Limerick Generating Station, Unit 2
Renewed Facility Operating License No. NPF-85
NRC Docket No. 50-353

Subject: Proposed Relief Request Associated with Reactor Pressure Vessel Nozzle Repairs

Response to Request for Additional Information

RELIEF REQUEST I4R-17, Revision 1

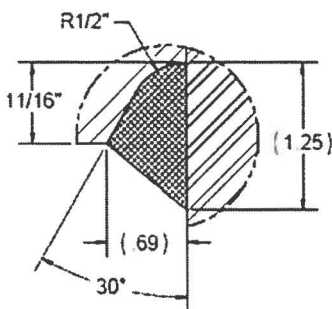
- (3) Wordings of the diagram in Enclosure 2 are not legible. Please, (a) Provide a legible diagram. (b) Provide the gap between the remnant nozzle and the new half

nozzle. Discuss whether the gap is sufficient for the thermal expansion of the remnant nozzle and new half nozzle.

A revised Enclosure 2 with the gap between the remnant nozzle and the new half nozzle is provided in Attachment 3. A gap of 1/16" to 1/8" will be left between the remnant of the original nozzle and the new nozzle. This gap is sufficient to absorb differential thermal expansion between the low alloy steel shell and the nozzle components and is consistent with Section III requirements.

Enclosure 2 - Reactor Pressure Vessel Level Instrument Nozzle Repair

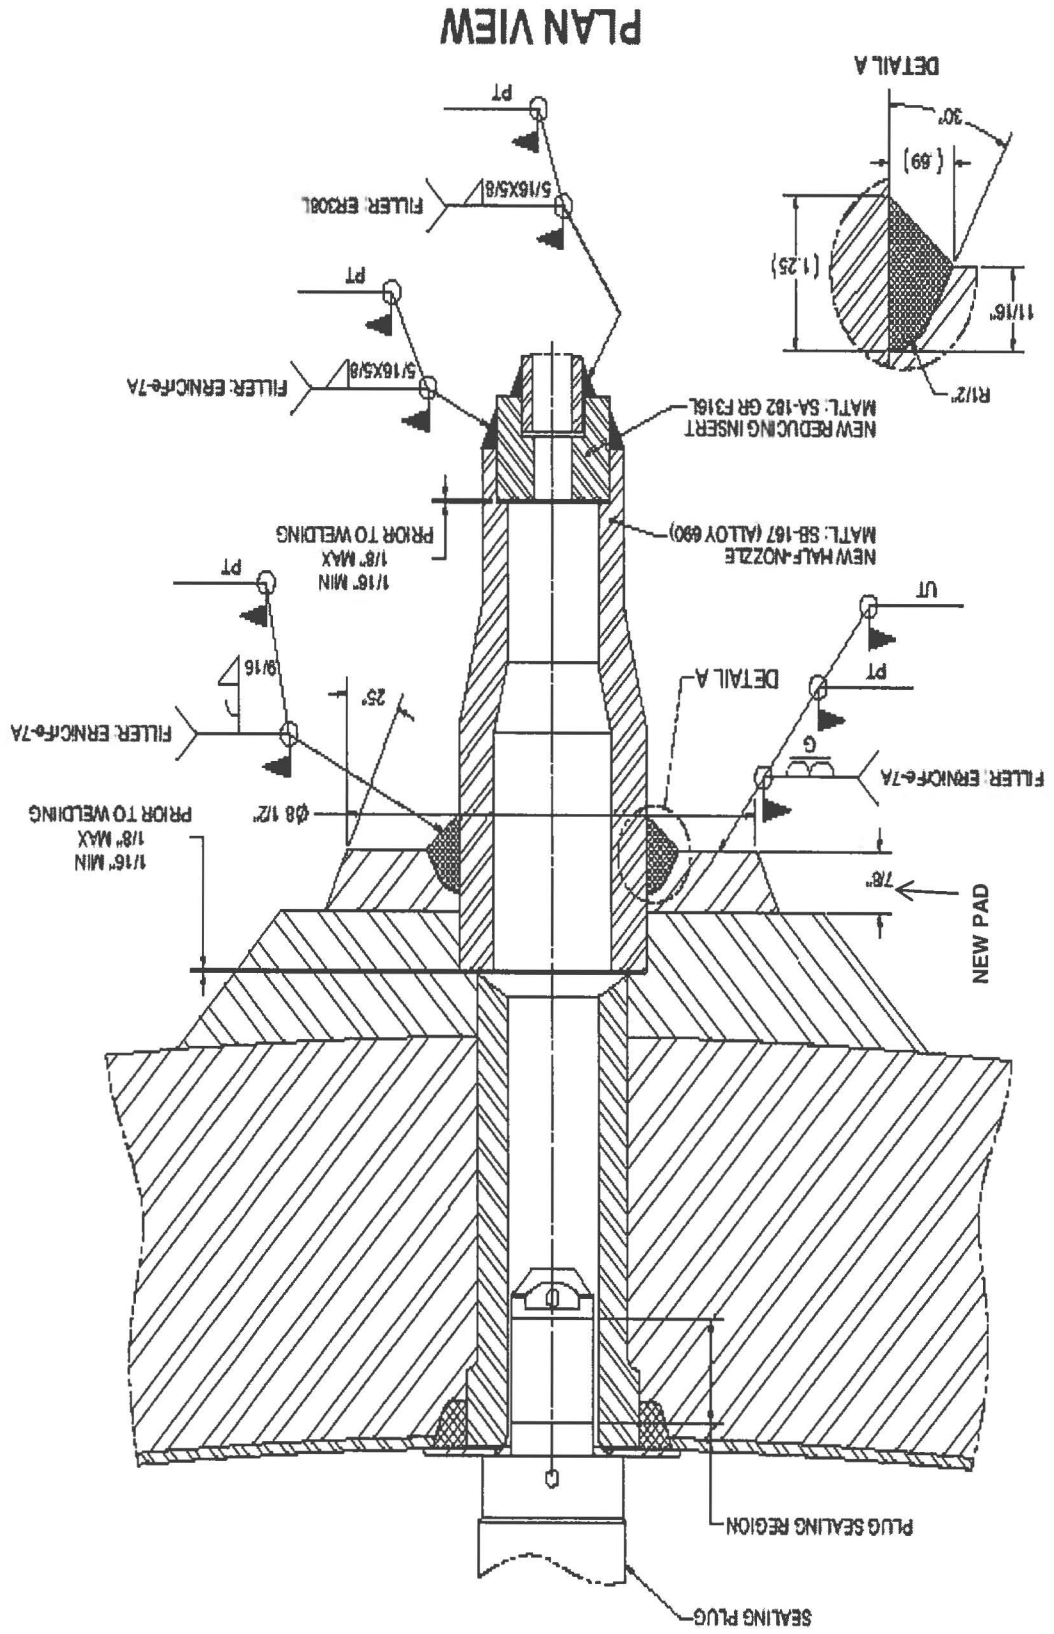
- (4) The proposed repair involves three new welds and a new reinforcement weld pad. The three welds are---a partial penetration weld joins the new half nozzle and the new reinforcement pad, a fillet weld joins the new half nozzle and new reducing insert, and a fillet weld joins the new reducing insert and the pipe. (a) Identify the size of the three welds and the thickness of the weld pad. (b) Discuss whether the welding of the three welds is performed in accordance with the ASME Code, Section IX. (c) Discuss the welding technique used on these three welds. (d) Discuss in detail the nondestructive examinations on the three welds. (e) Discuss whether all three welds and the weld pad are considered the pressure boundary. (f) Discuss whether a pressure test will be performed in accordance with the ASME Code, Section XI after the repair but prior to the plant startup.

- a) The sizes of the three welds and the thickness of the weld pad are as follows:

- Partial penetration weld with fillet reinforcement (see diagram below)

- Fillet weld between replacement nozzle and reducing insert = 5/16 x 5/8 inch leg sizes
- Fillet weld between reducing insert and piping = 5/16 x 5/8 inch leg sizes
- Alloy 52M weld build-up pad thickness = 7/8 inch

The weld sizing and weld pad thickness dimensions have also been added to the diagram as provided in response to RAI-3 which is contained in Enclosure 2 to the revised relief request (Attachment 3).
